City of Fredericksburg

Planning and Zoning Meeting Agenda
Wednesday, March 5, 2025 ~ 5:30 PM
New City Hall at East Campus
2818 E. U.S. Hwy. 290
Fredericksburg, Texas 78624

**PLANNING & ZONING COMMISSION
January 8, 2025
5:30 P.M.**

SHEET NAME & NO.: SITE PLAN A01.01

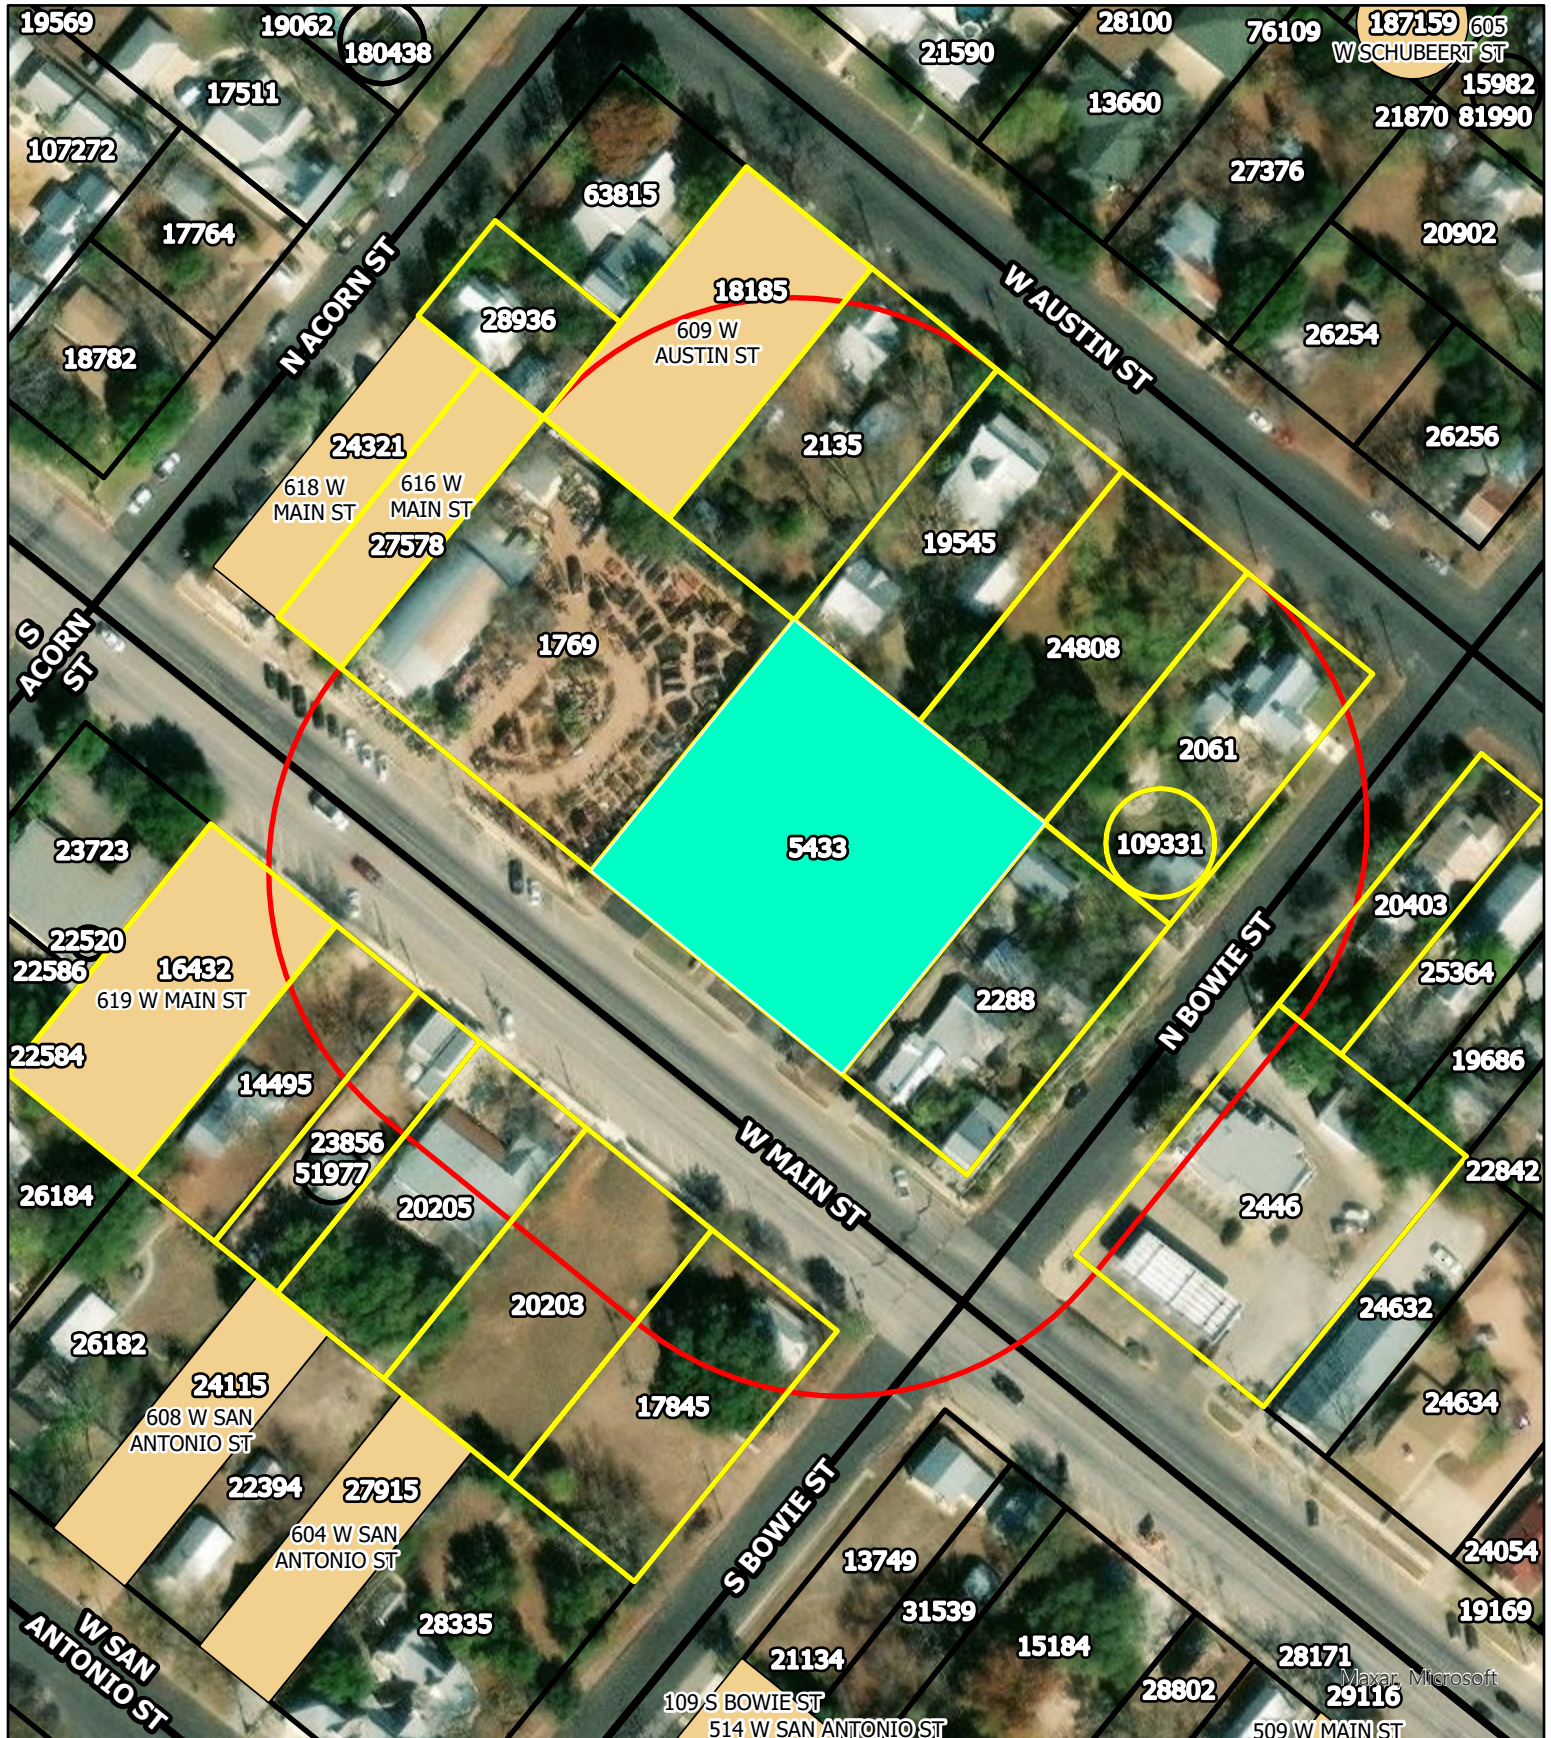
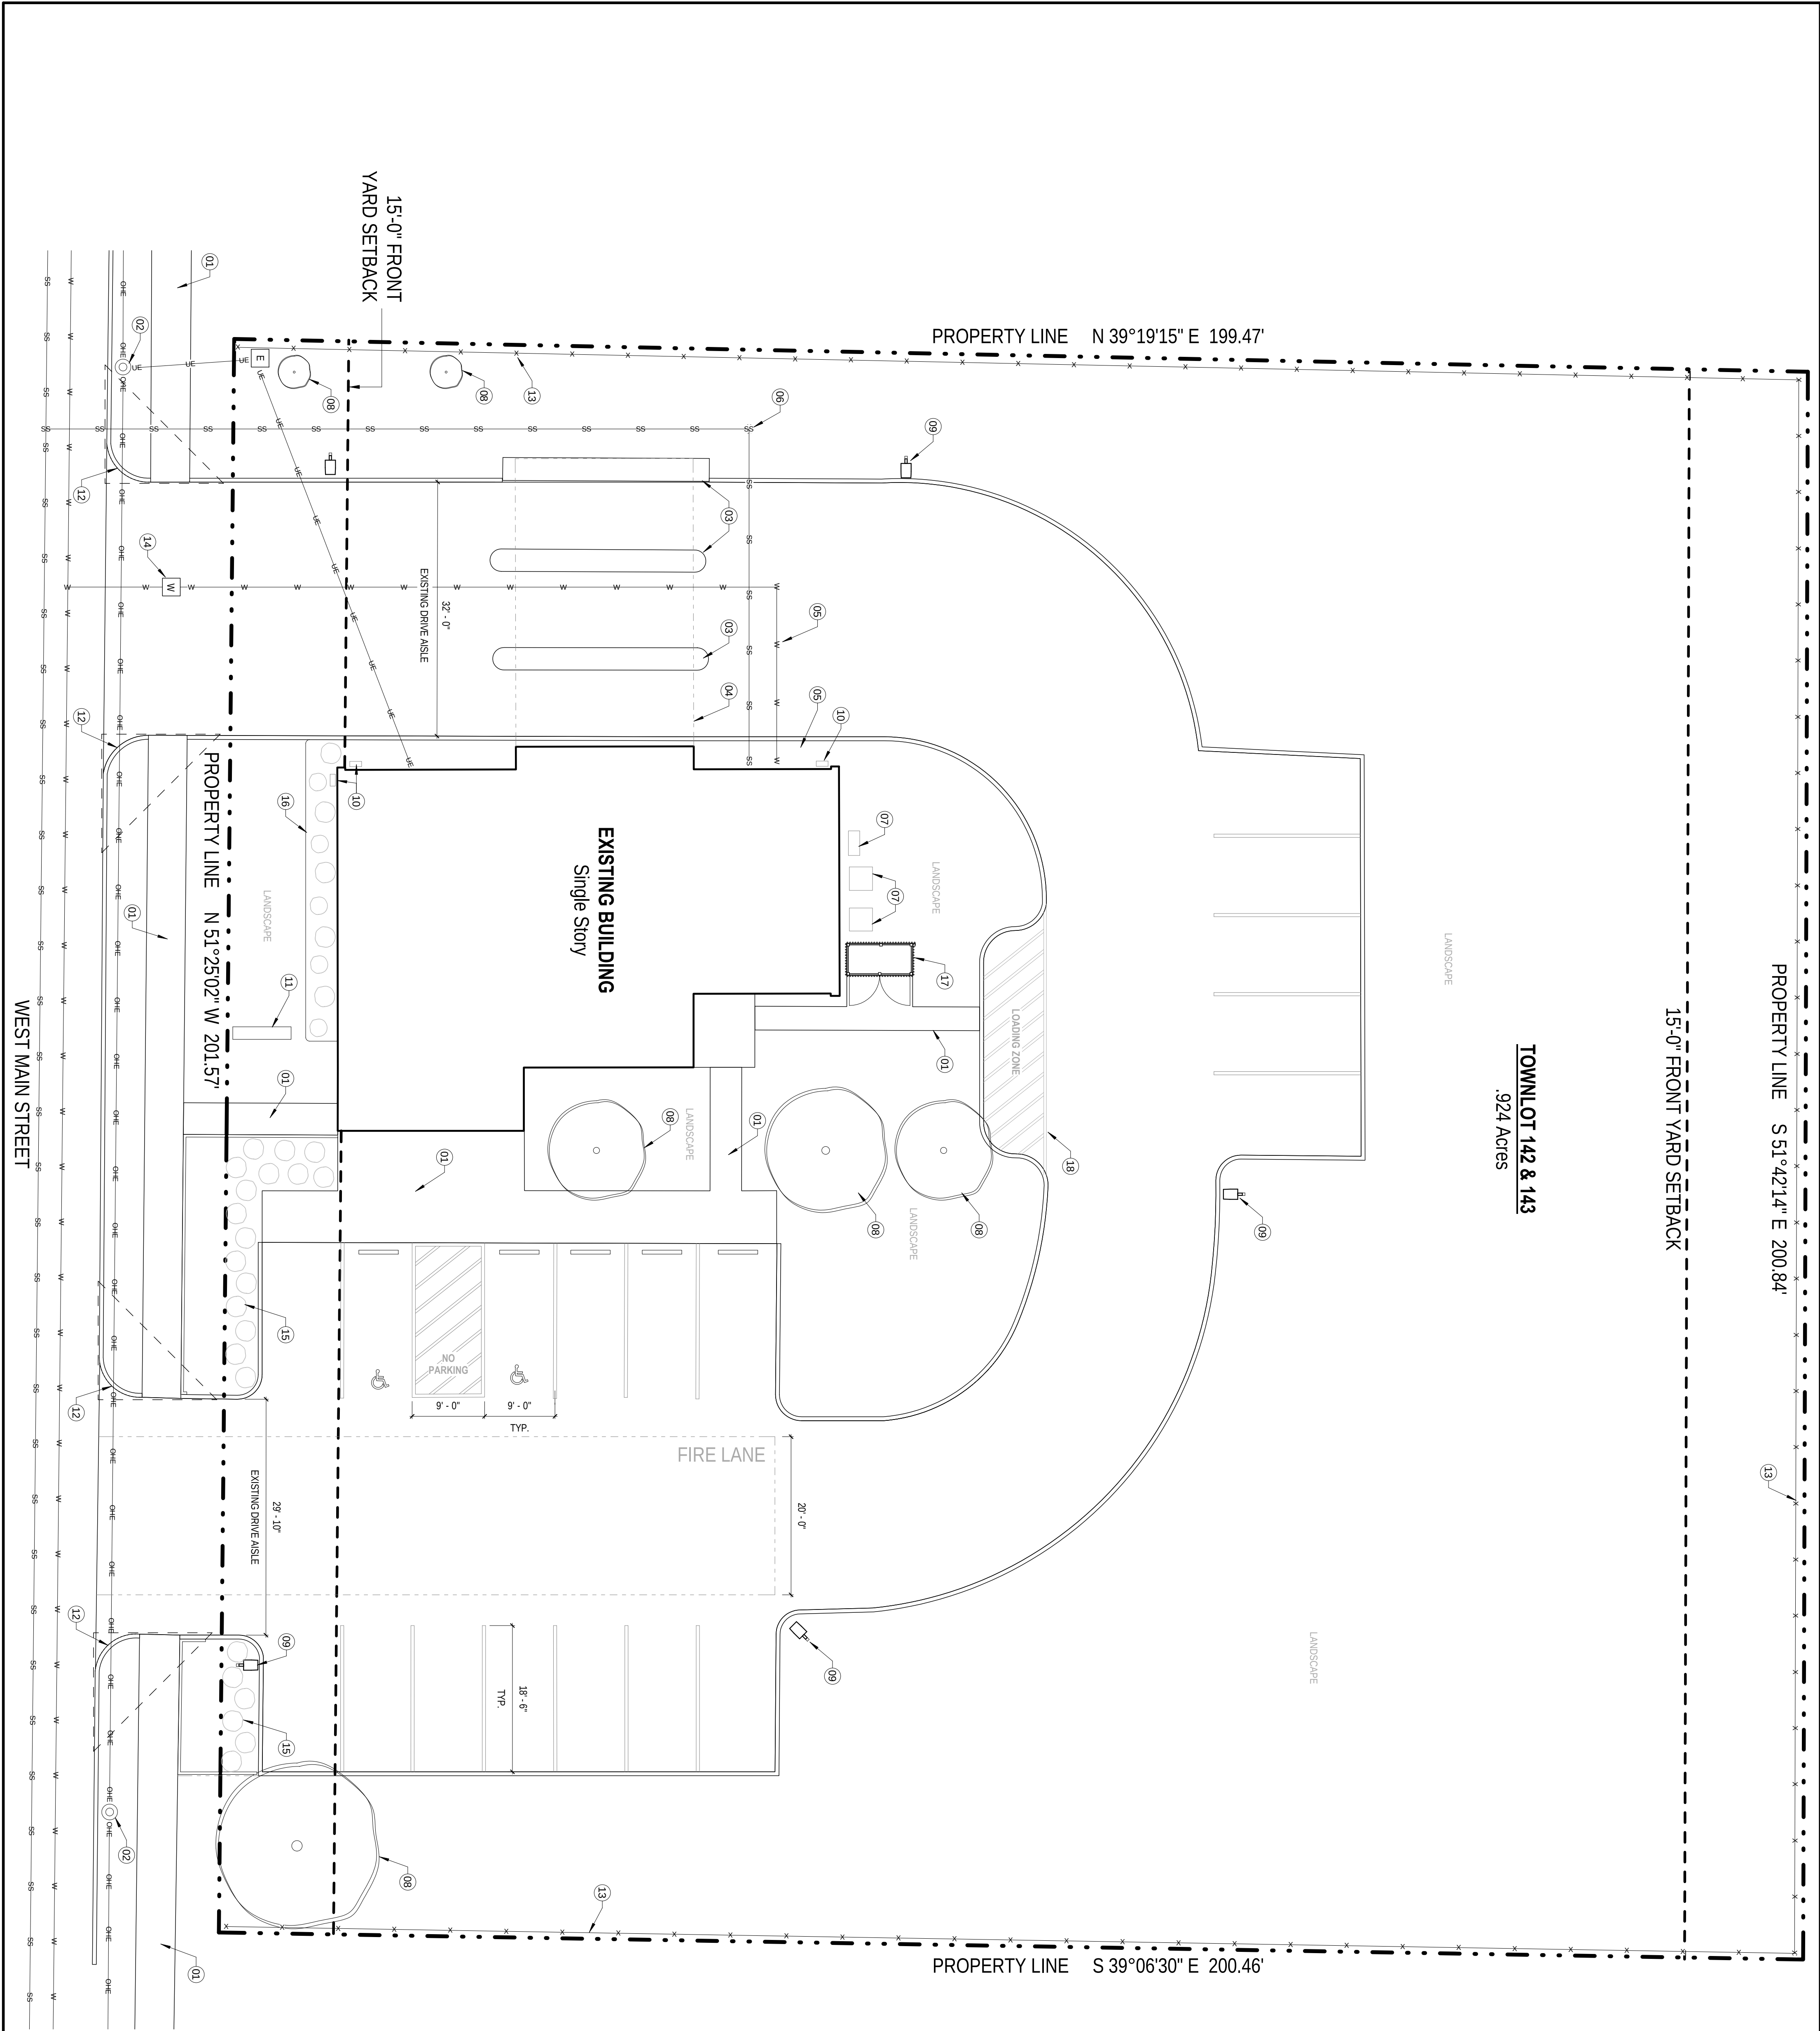
- Provide a notarized document indicating the number of current and/or proposed locations as well as the closest location to Fredericksburg, Texas. [Sec. 5.461](#)
- Renderings of signage to include placement and colors as well as examples of signage at other locations. [Sec. 5.461](#)
- Provide sign proposals, must be compliant with [Chapter 29 – Sign Ordinance, 29-7,3](#)
- Identify loading/unloading zones [Sec. 7.131](#)
- Identify placement of dumpster and/or trash receptacles [Sec. 7.131](#)
- All refuse collection must be screened per [Sec. 7.940](#)

- Please provide a solid waste container with appropriate screening per Section 7.980 of the City's Code of Ordinances.
- Please keep all proposed landscaping within the property line.

7. Please provide a solid waste container with appropriate screening per Section 7.980 of the City's Code of Ordinances.

The Site Plan has been revised to include a dedicated loading zone. Refer to attachment.

Trash receptacles and an enclosure has been located Plan-North of the existing building. The Site Plan has been revised to include trash receptacles. Refer to attachment.

The Site Plan has been revised to include a trash receptacle enclosure. Refer to attachment.

Trash receptacles and an enclosure has been located Plan-North of the existing building. The Site Plan has been revised to include trash receptacles. Refer to attachment.

The Site Plan has been revised accordingly. Refer to attachment.
